ADDENDUM NO. 2

September 19, 2025

VALE FACILITY ADDITION/RENOVATIONS AND MAINTENANCE/IT FACILITY PROJECTS

Addendum Two (AD.02) to the drawings and specifications prepared by Gibraltar Design for **Valparaiso Vale Facility Addition/Renovations and Maintenance/It Facility and Related Work** for Valparaiso Community Schools, Valparaiso, Indiana.

6 A-411A **WALL SECTION**
3/4" = 1'-0"

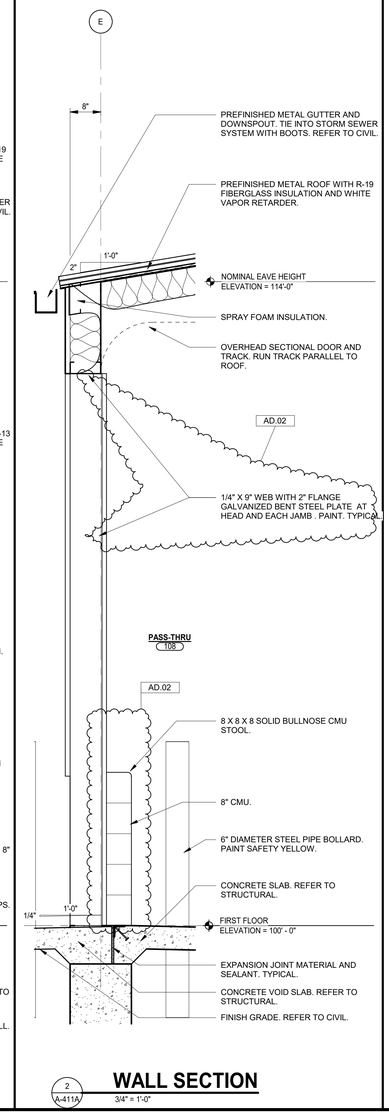
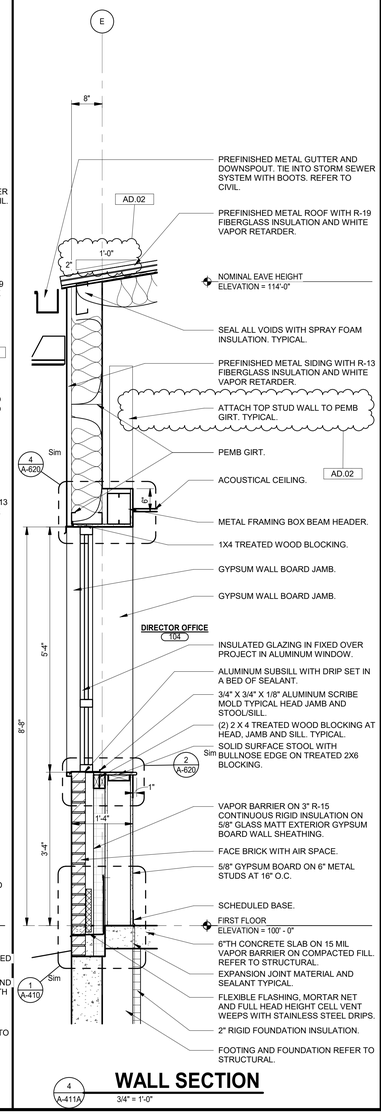
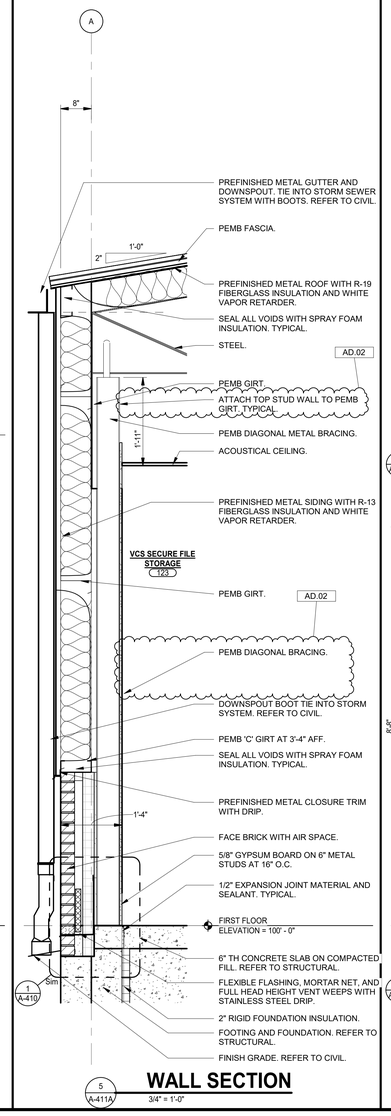
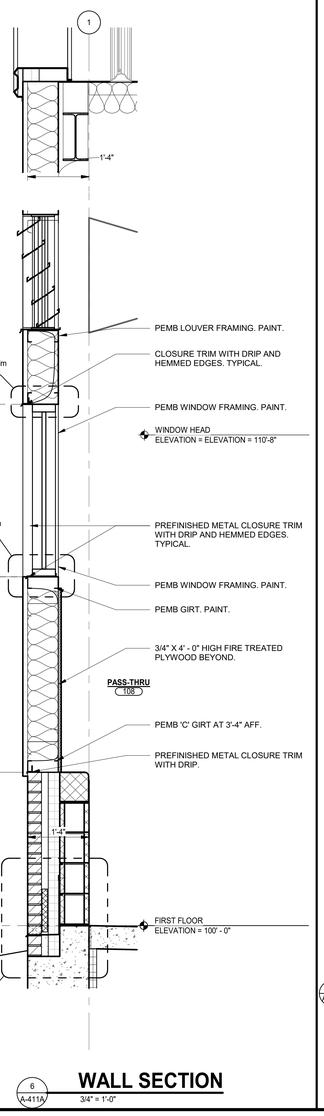
1. Revised sections 2/A-411A, 4/A-411A, 5/A-411A and 6/A-411A.

7 / A-412 — 1/2" = 1'-0"

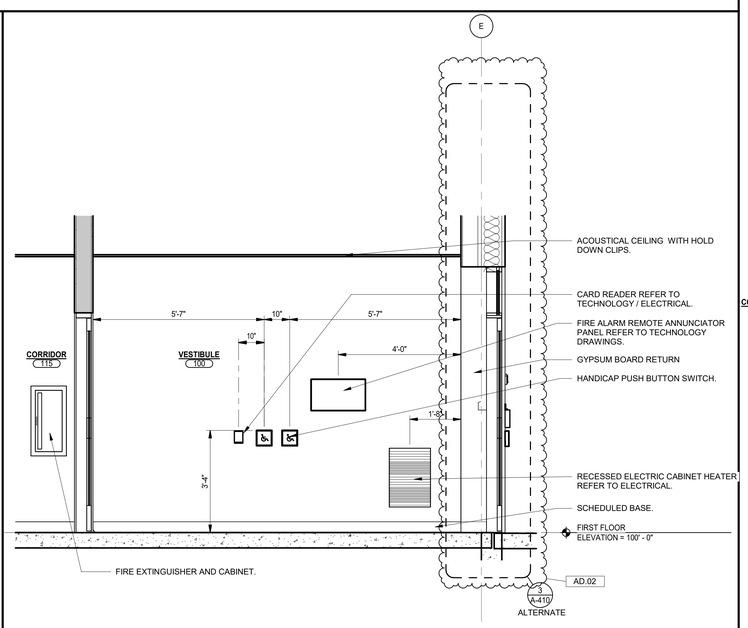
1. Revised Elevation Vestibule 100 7/A-412.

1 ROOF FRAMING PLAN - UNIT C
1/8" = 1'-0"

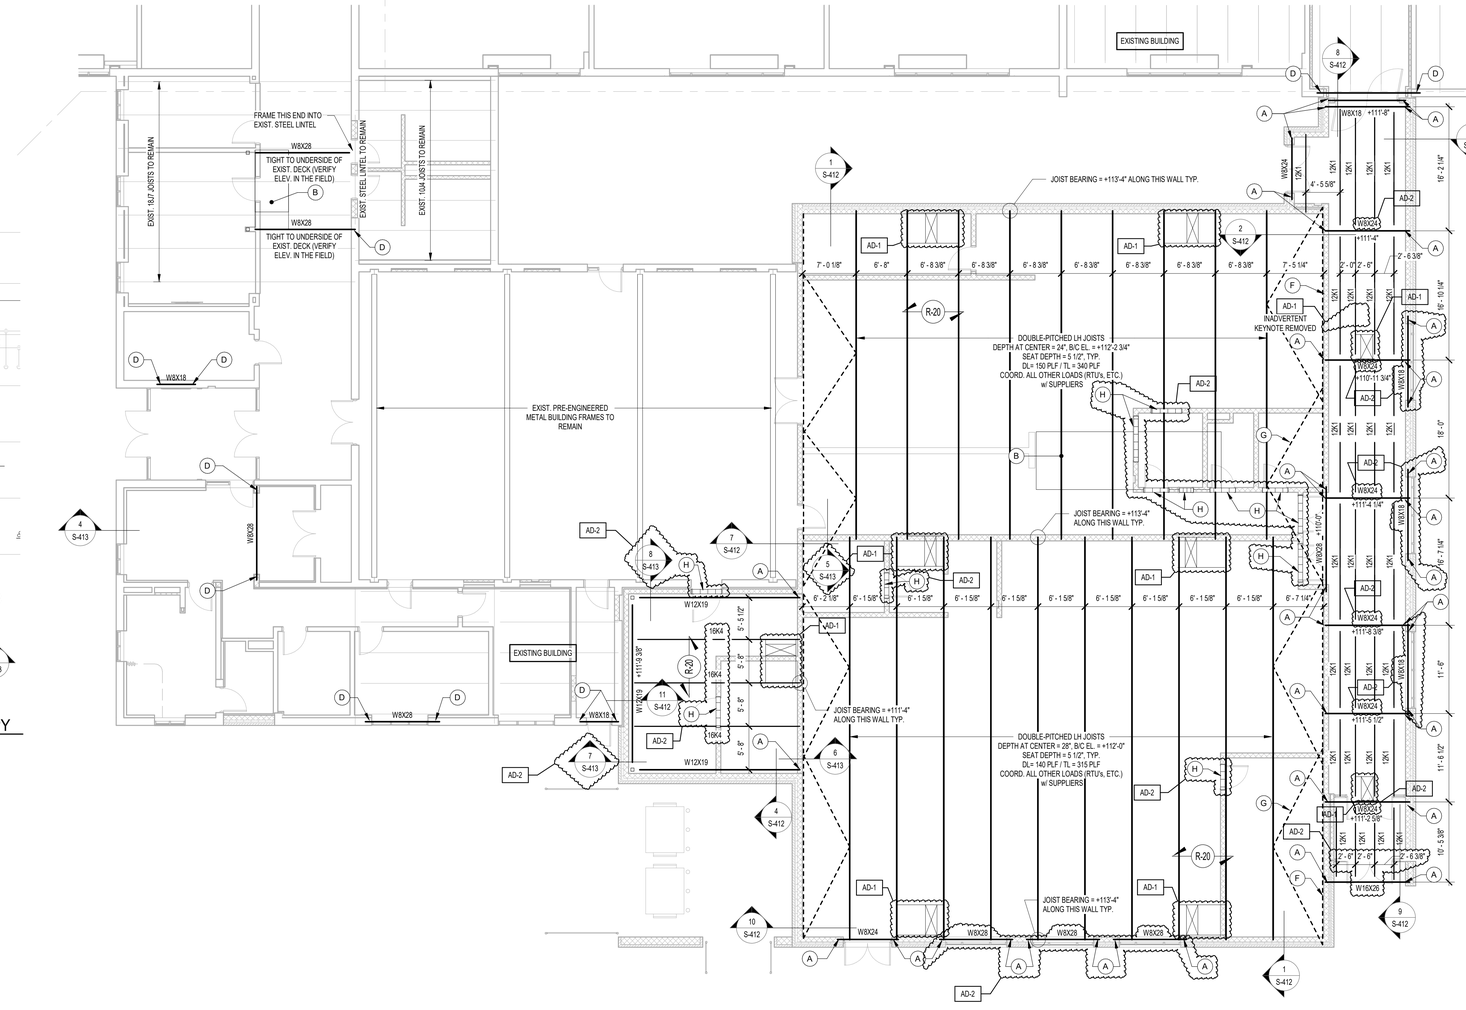
A. Refer to revised, full-size drawing, included in this Addendum, for revisions below.
   1. Steel Beam and Joist sizes Modified
   2. Steel Lintels at Openings added
   3. Concrete Block Lintels added
   4. Roof Framing Keyed Note H Modified
   5. Roof Framing Plan Notes Diagram Modified
   6. Framing Sections Added

19 A-210 ROOF LADDER
1" = 1'-0"

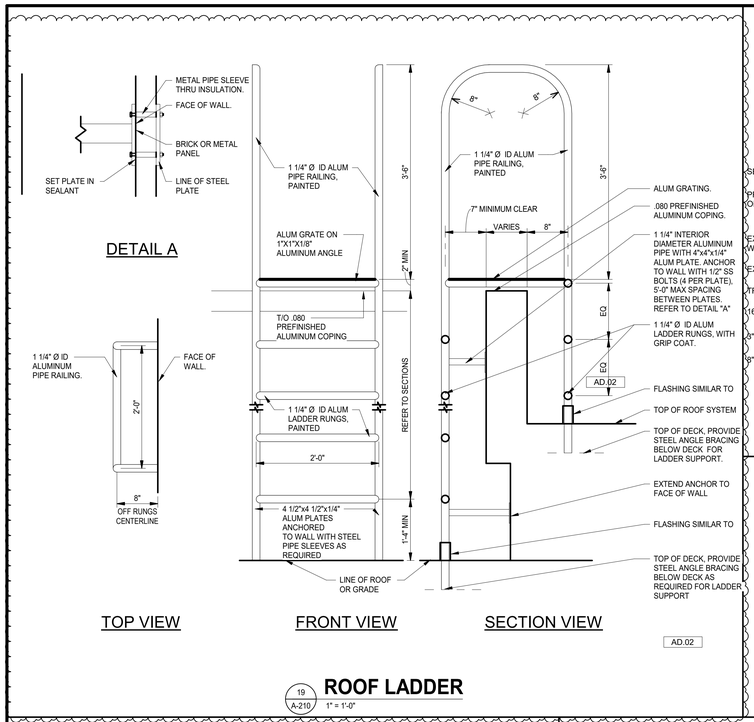
1. Detail 8 note clarification and added typical roof ladder detail.

7 A-411 **VESTIBULE C-122 SECTION**
3/4" = 1'-0"

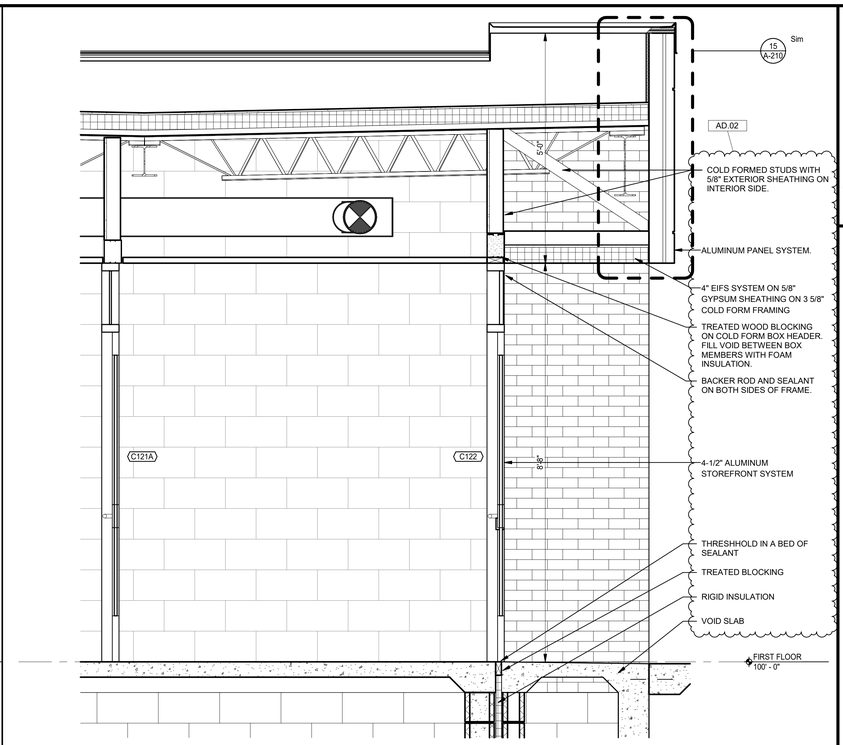
1. Added top of masonry elevations and added notes to detail 7 and 10.

2 A-501 **GATE HINGE DETAIL**

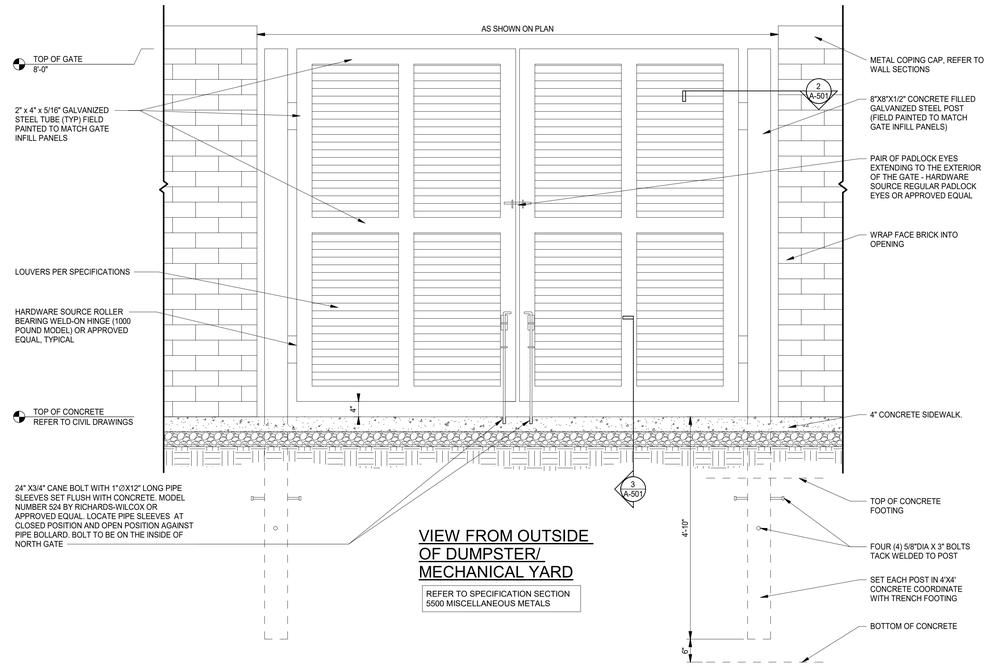
1. Added details 2/A-501 and 7/A-501.

1 PD101 **UNIT "A" PLUMBING FIRST FLOOR DEMOLITION PLAN**

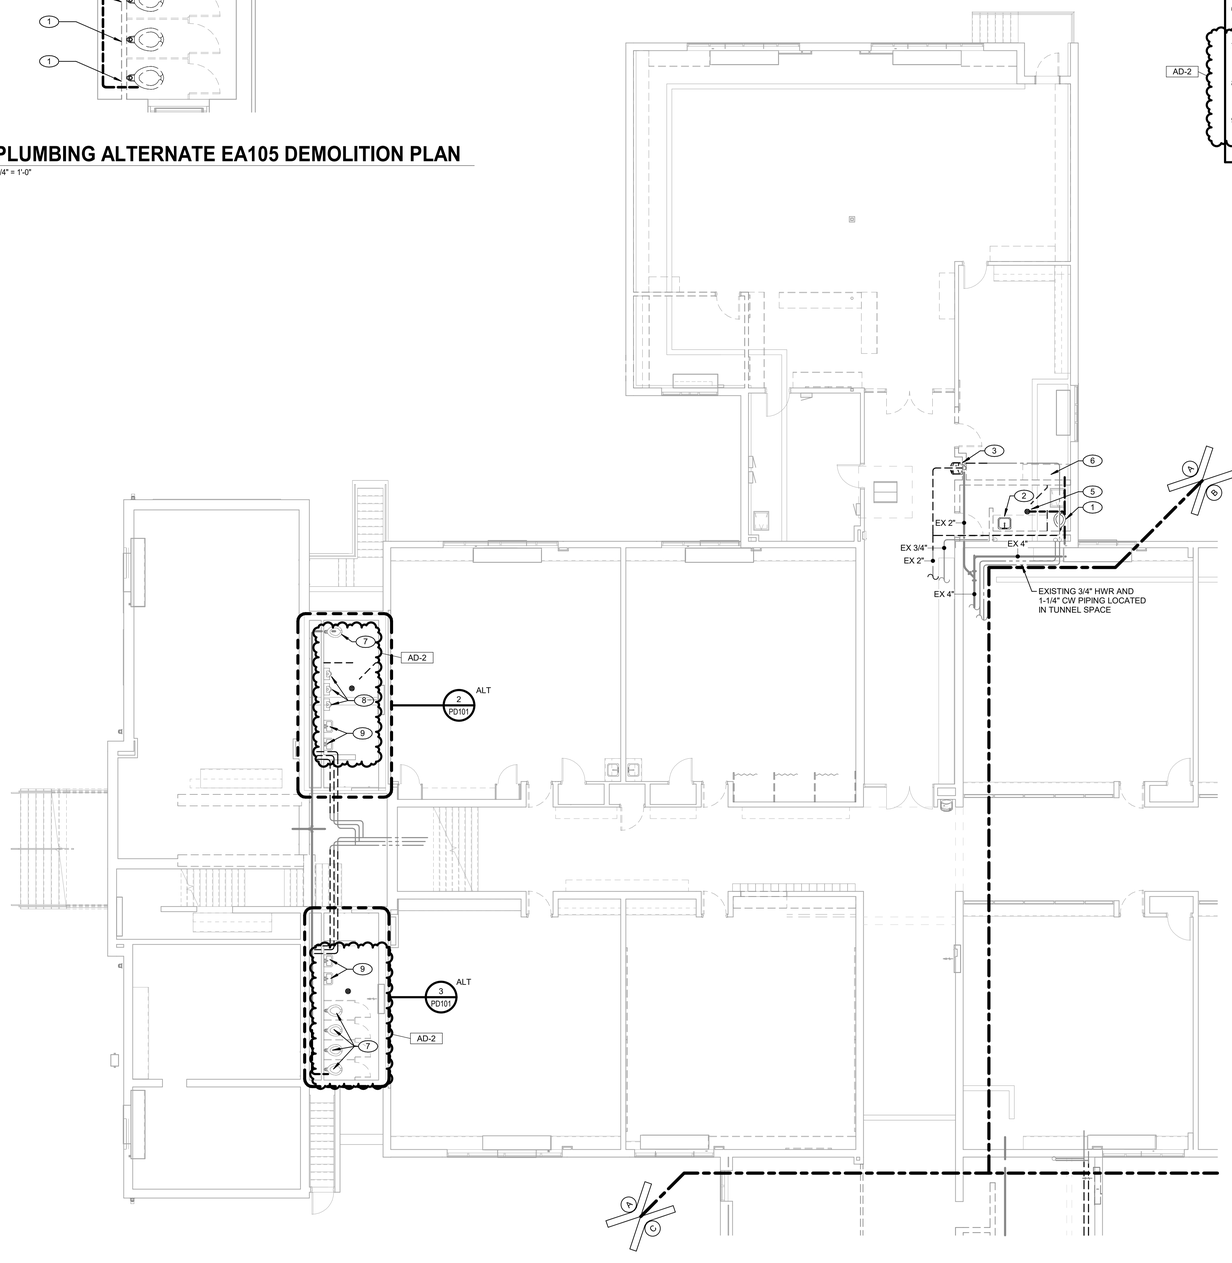
A. Refer to revised, full-size drawing, included in this Addendum, for revisions below.
   1. Revised base bid scope in bathrooms EA105 and EA108.
   2. Added sheet notes.

UNIT "B" PLUMBING FIRST FLOOR DEMOLITION PLAN

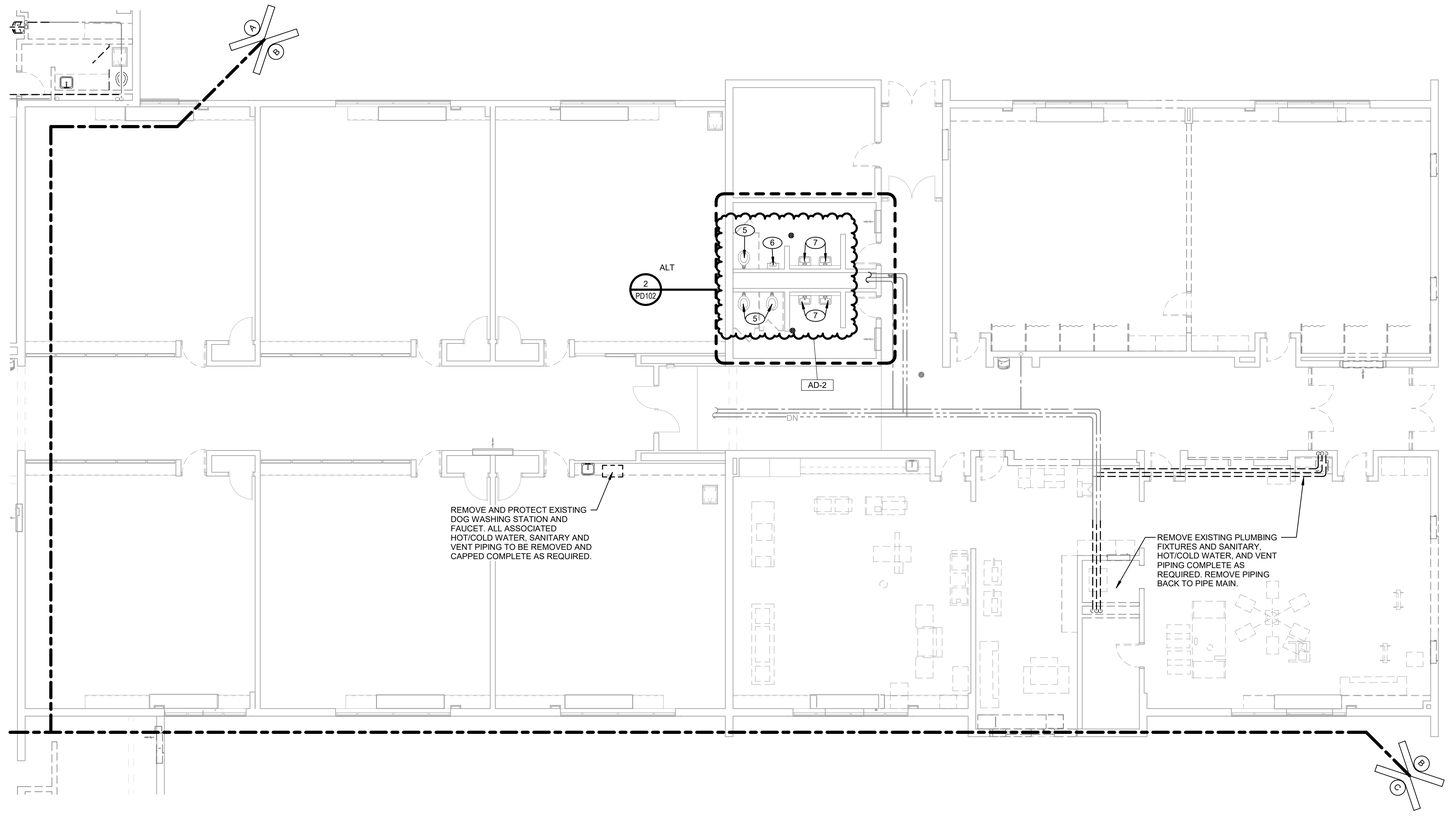
A. Refer to revised, full-size drawing, included in this Addendum, for revisions below.
   1. Revised base bid scope in bathrooms EB110 and EB111.
   2. Added sheet notes.

1 P-103 **UNIT "C" PLUMBING UNDERFLOOR PLAN**

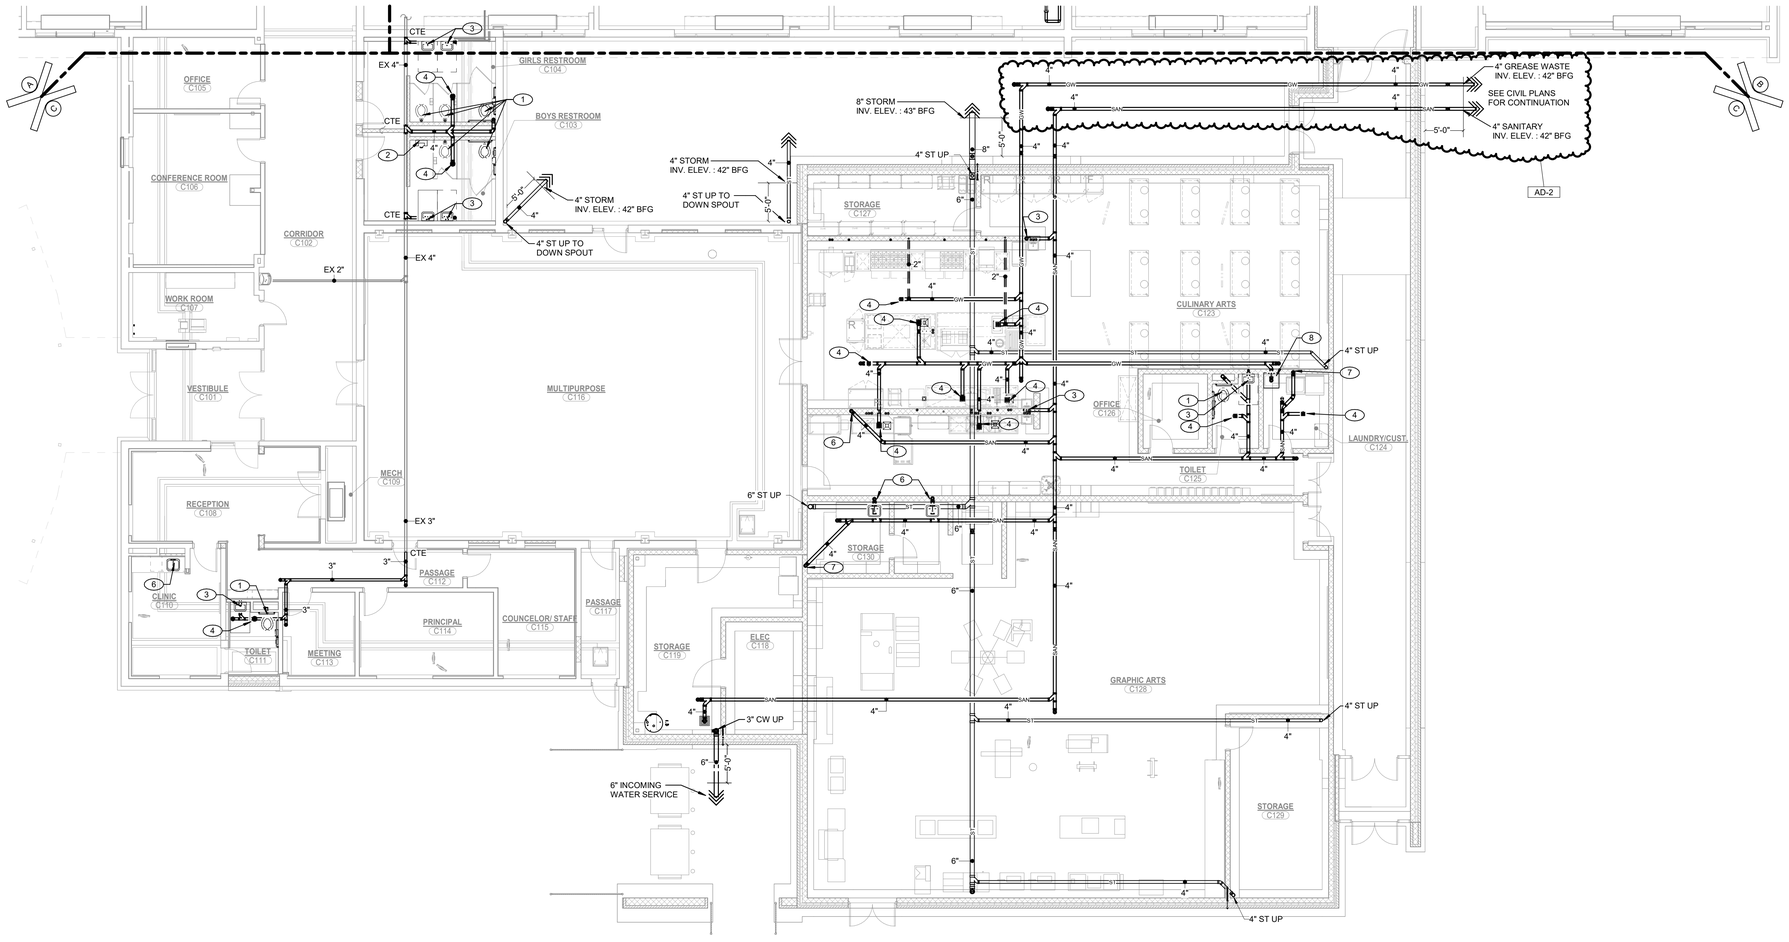
A. Refer to revised, full-size drawing, included in this Addendum, for revisions below.
   1. Revised storm and greasy waste lines.
